PERCOLATION TESTING

A 47952
P _____

RE: Percolation Testing Rescheduling
Gnenasundram Property
Baltimore National Pike
Tax Map: 1 Parcel: 45
8.83 Acres

RE: Percolation Test Results Application
Number: 47952
Proposed Use: Single Family Dwelling
Property ID: Parcel: 45 Tax Map: 1
8.83 Acres (Existing
Recorded Lot)

5/14/92

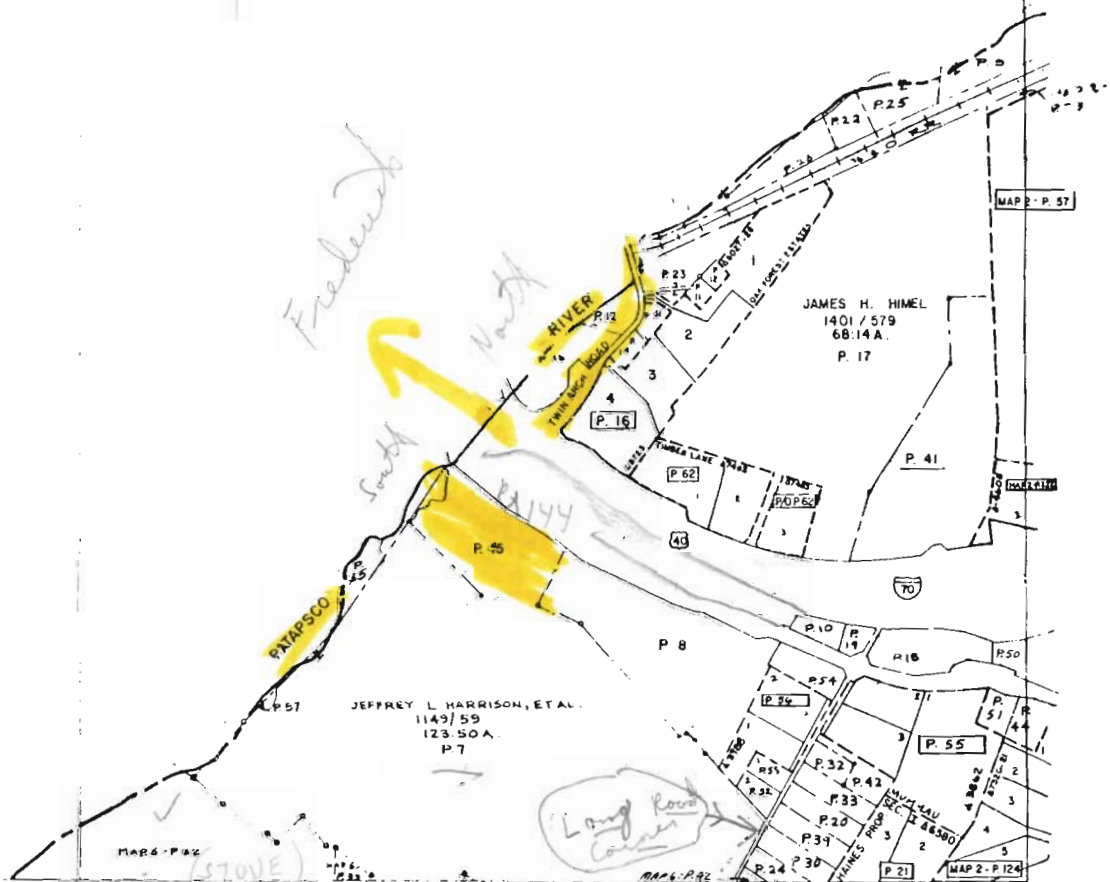
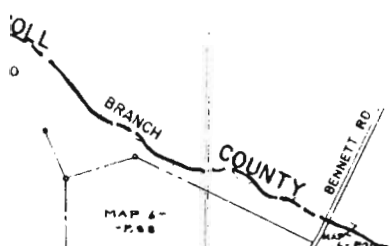
② [all holes are in woods]

③ Shallow system only

④ Hold for perc plat etc.
